STEP BY STEP EARLY LEARNING CENTER

JULY 09, 2024

1st Review
PRCCP20241109
August 2024

C3.10

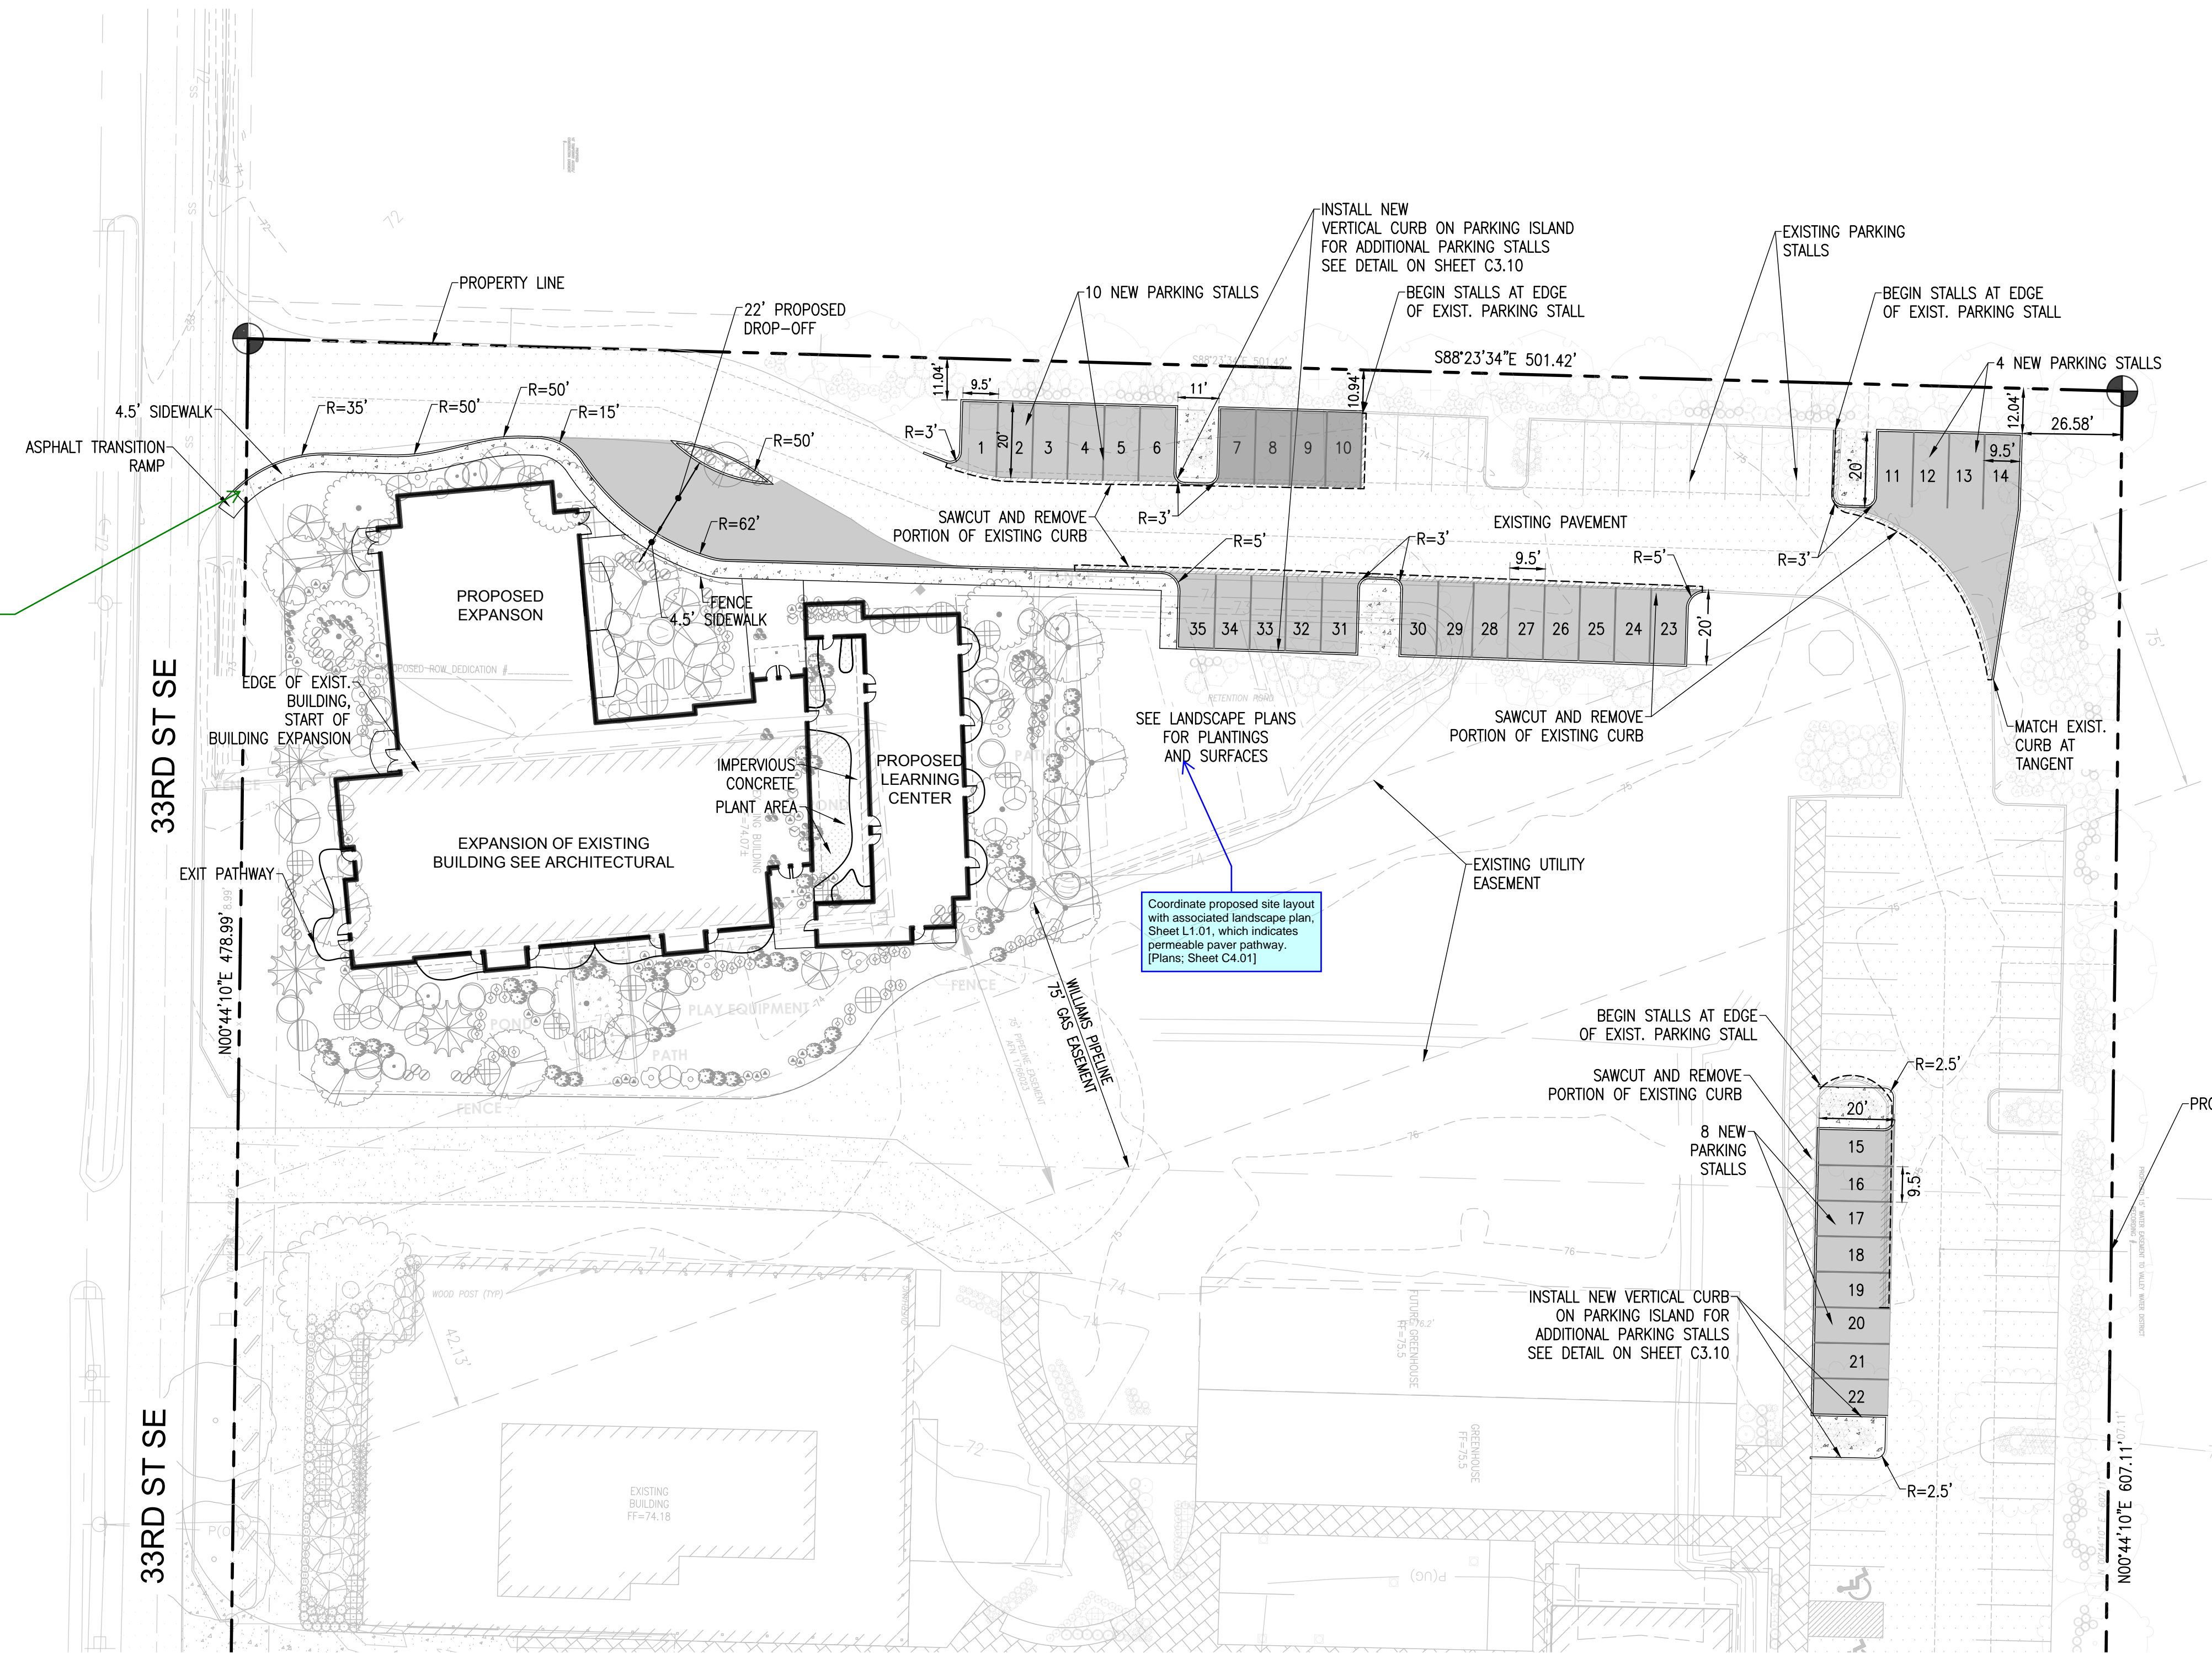
Please add CB filter sock detail. (Plans: Sheet C3.10)

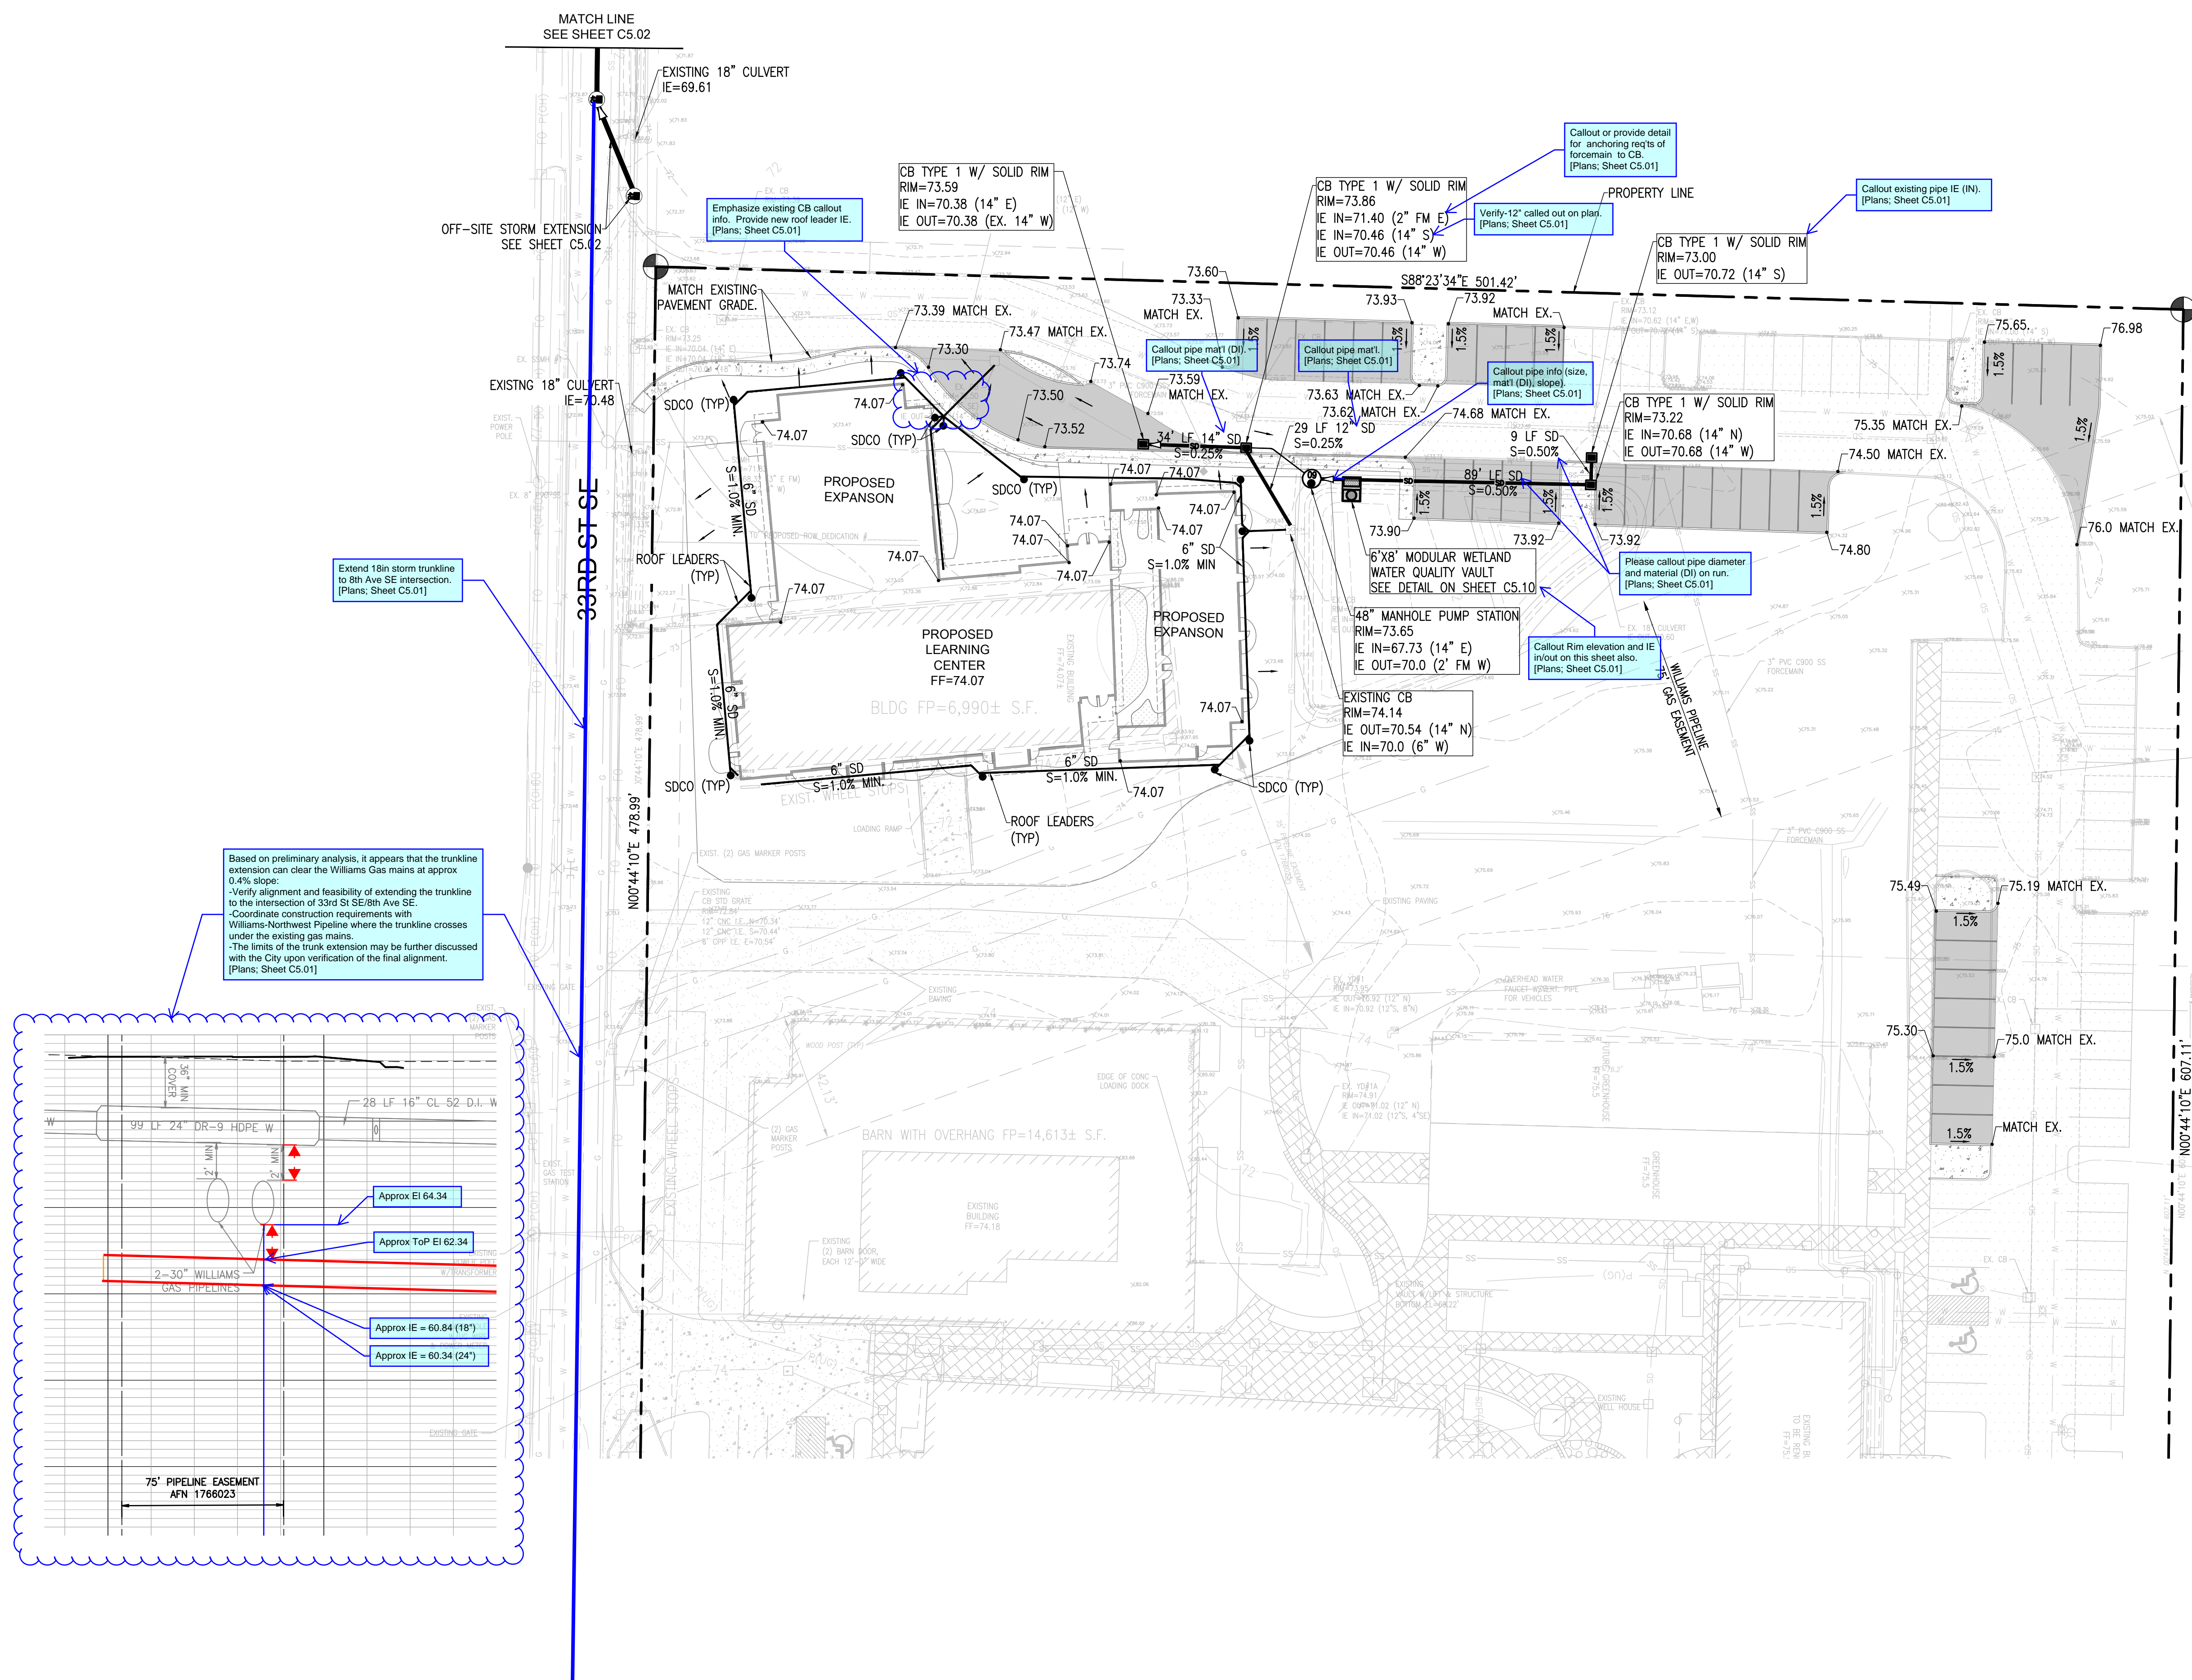
Based on preliminary analysis, it appears that the trunkline extension can clear the Williams Gas mains at approx 0.4% slope:
 -Verify alignment and feasibility of extending the trunkline to the intersection of 33rd St SE/8th Ave SE
 -Coordinate construction requirements with Williams-Northwest Pipeline where the trunkline crosses under the existing gas mains.
 -The limits of the trunk extension may be further discussed with the City upon verification of the final alignment.
 [Plans, Sheet C5.01]
